PLANNING COMMISSION MEETING AGENDA

MAY 2, 2023

1. LSDP: Cheltenham Townhomes

3. LSDP: Jiffy Trip

19. PROPOSED LANDSCAPING MUST BE PROVIDED IN ACCORDANCE WITH THE REQUIREMENTS OF ARTICLE III. LANDSCAPING MUST BE INSTALLED OR BONDED PRIOR TO ISSUANCE OF CERTIFICATE OF OCCUPANCY, IN ADDITION TO A THREE-YEAR MAINTENANCE AND REPLACEMENT AGREEMENT PROVIDED BY OWNER.

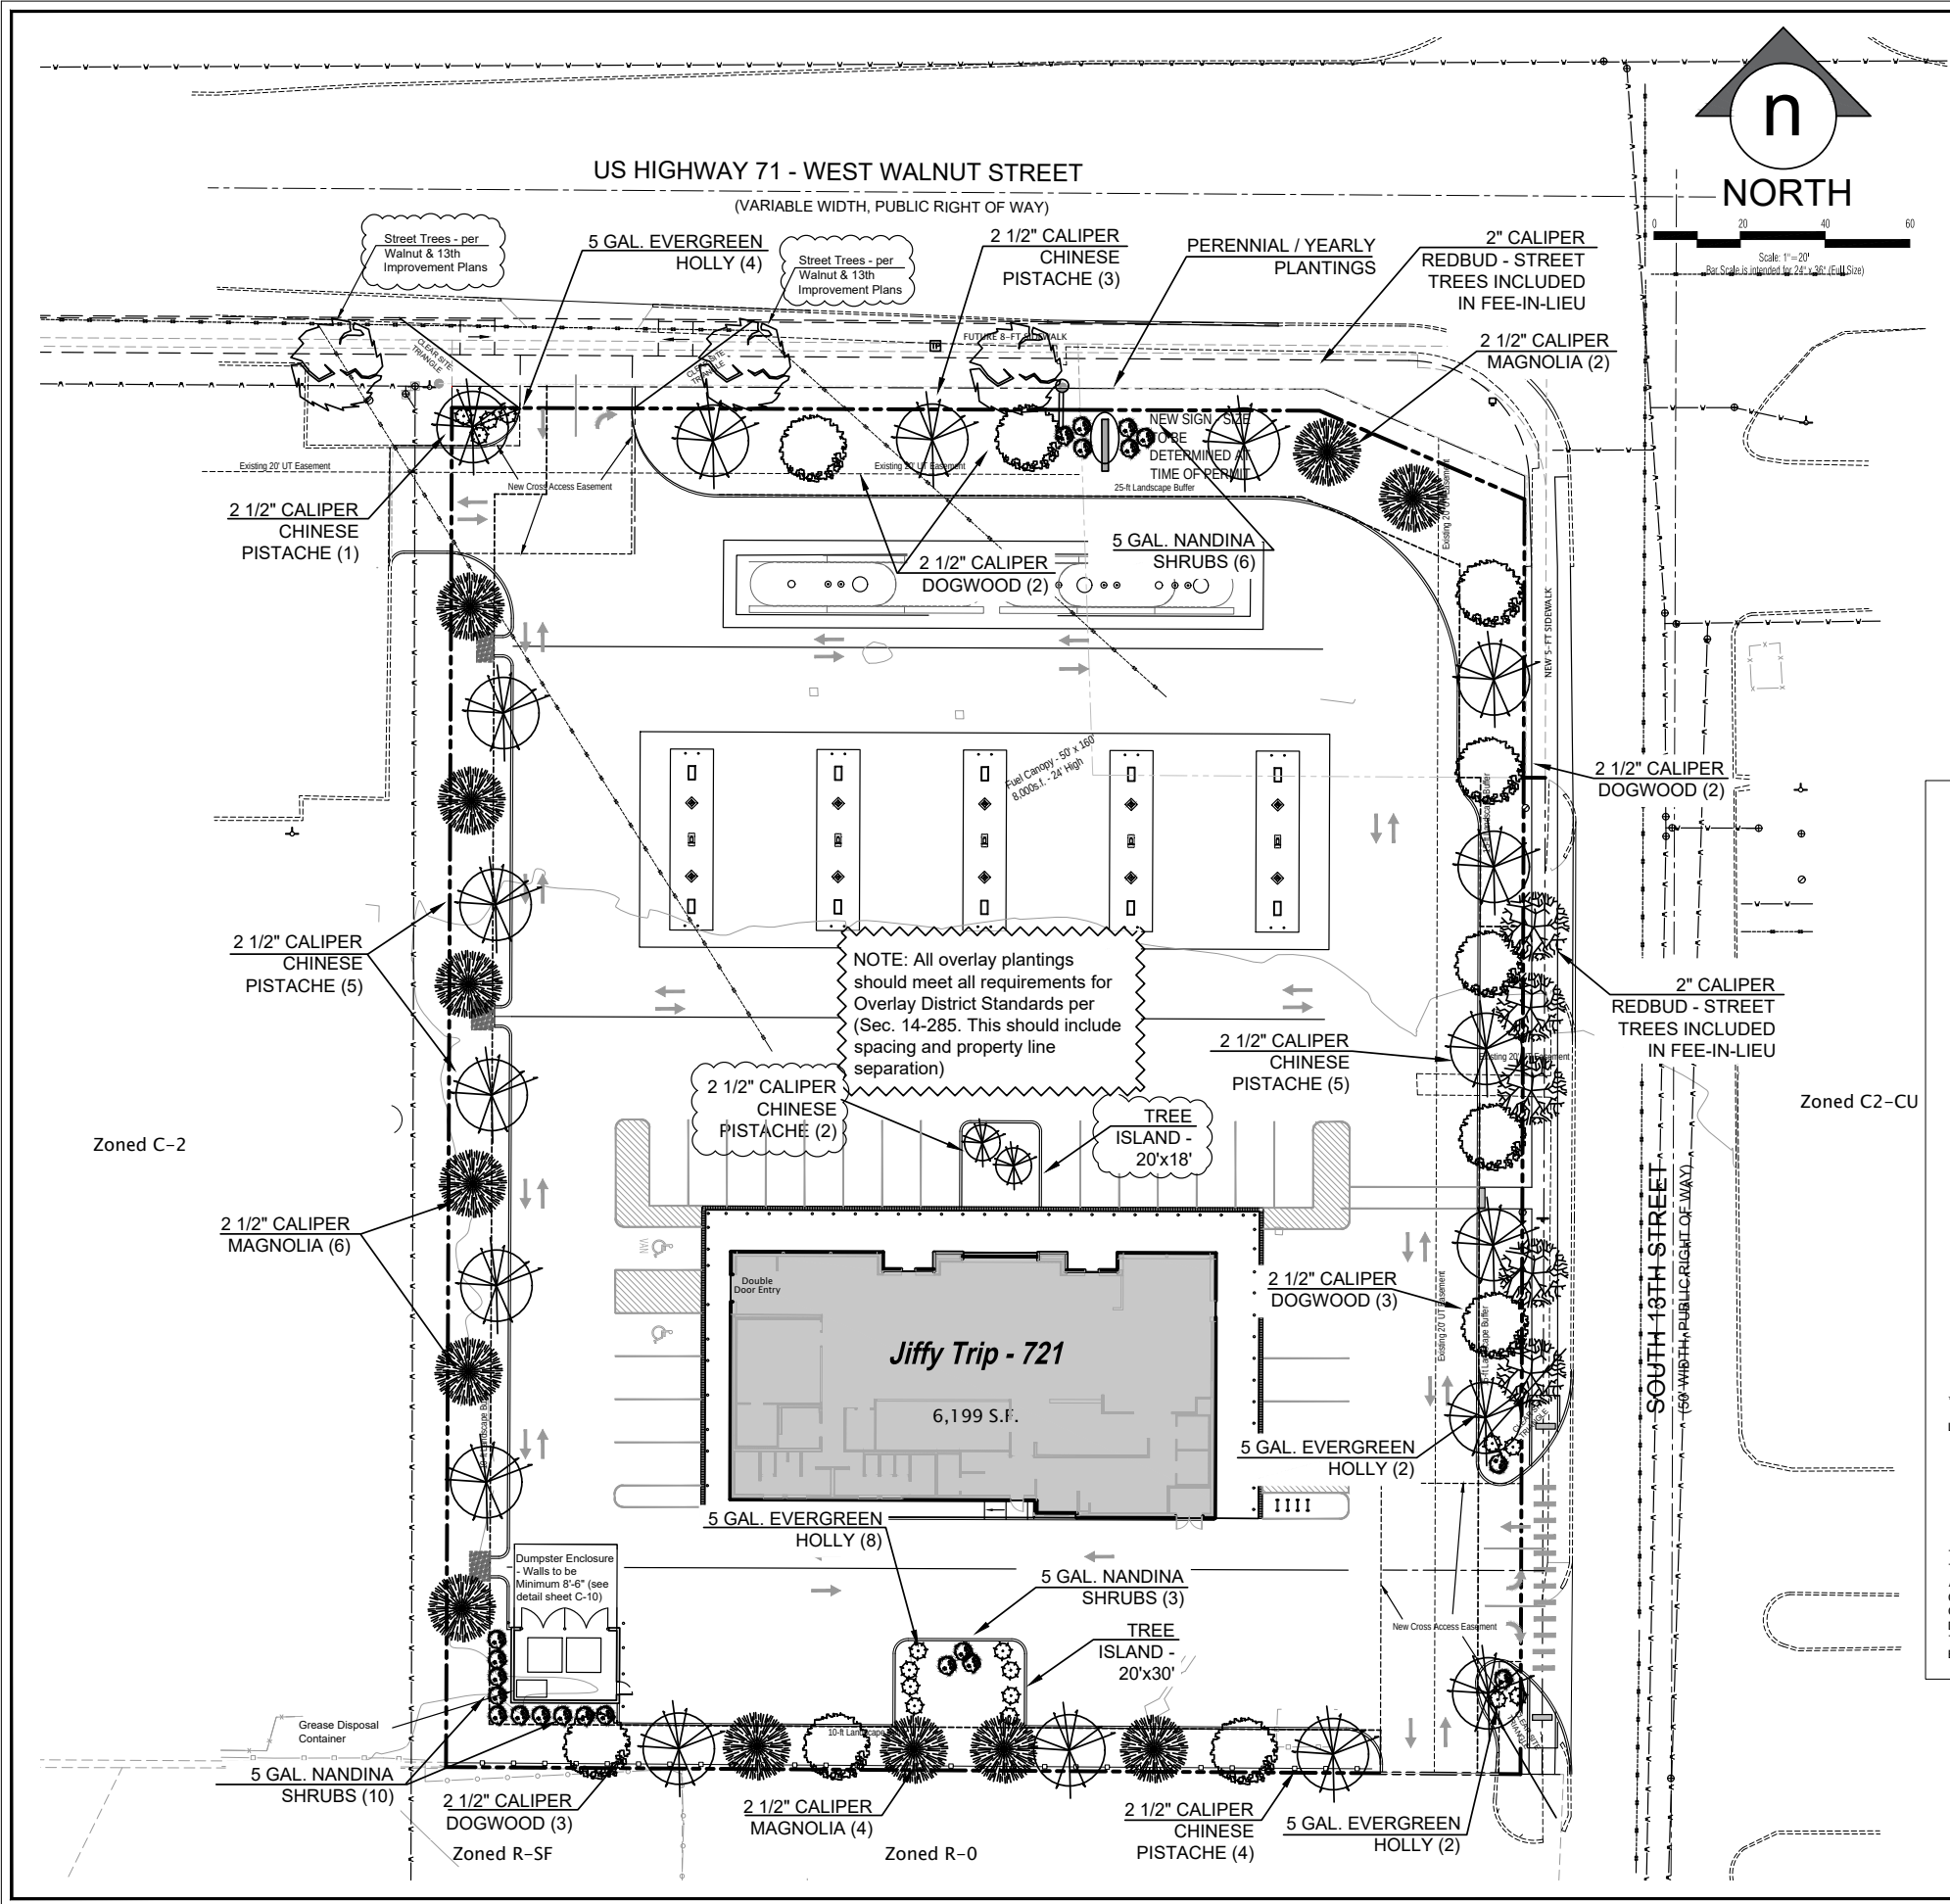
4. Correct the note on Sheet C-7, "CONNECT NEW 6-IN SANITARY SEWER SERVICE TO EXISTING MANHOLE (Per City of Rogers Spec.)" to state (Per Rogers Water Utilities Spec.)

6. On sheet C-7, what is the note "New 4" Sanitary Service – by Highway Improvement Design" for. There is no Highway Improvement Design, and it is pointing to a sewer service line that is called to be removed on the Demolition Plan Sheet.

7. On sheet C-7, the text box for the water meter notes the water meter is for Irrigation, but is connected to the building. Should this be 2 water meters (one domestic and one irrigation)? Or is the note for Irrigation in error?

8. On sheet C-7, that are text boxes that are not pointing at the items being referenced. See text box with "INSTALL 6-IN CLEAN-OUT" at the southwest corner of the plans for an example.
